**Group of Experts for the revision of the IMO/ILO/UNECE
Guidelines for Packing of Cargo Transport Units**

**Comments (USA) submitted on the Code of Practice for
packing of Cargo Transport Units (CTU Code)**

Code of Practice for Packing of Cargo Transport Units (CTUs)
(CTU Code)

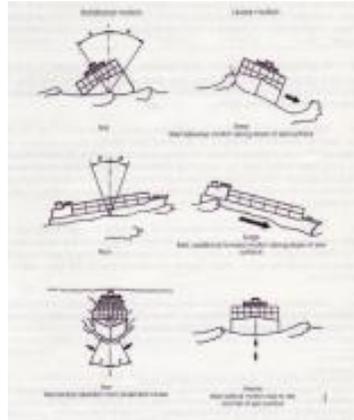
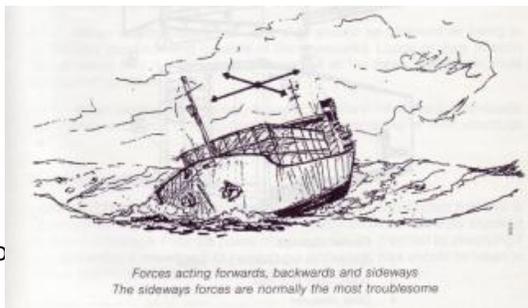
Comment [e5]: The two pictures below, of the ship forces, need to be bigger and have some context of why they are being added.

Figure 5 – checking a container

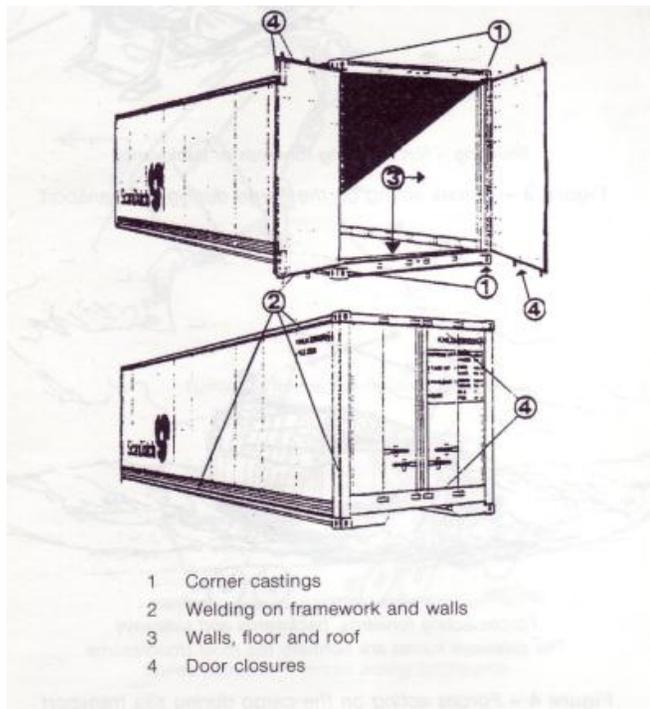
Comment [e2]: Is this paragraph referring to the figure below and if so, it needs to be referenced to and have a number.

7.9.9 Blocking between rows within a cargo section:

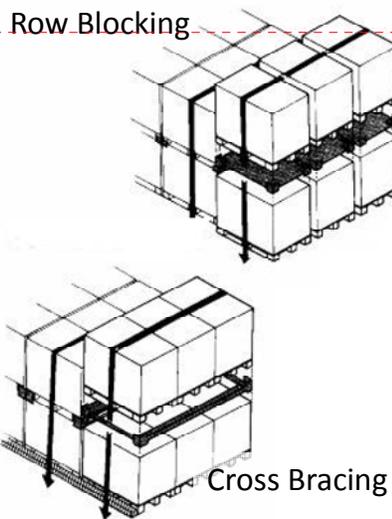
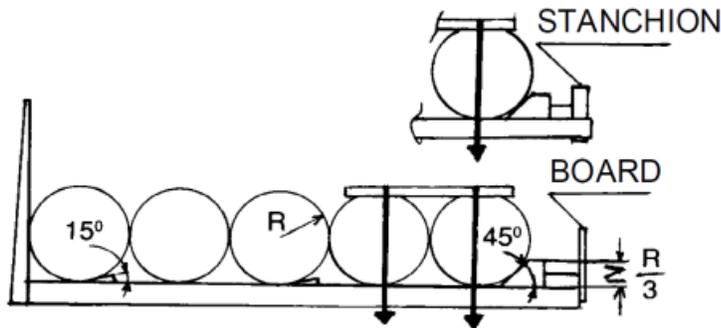
Comment [e5]: Would suggest that the cross bracing and row blocking paragraphs be switched. Purely because in the figure the Row Blocking is above the Cross bracing and it would be easier for the person reading these guidelines to see the corresponding picture beside its corresponding paragraph.
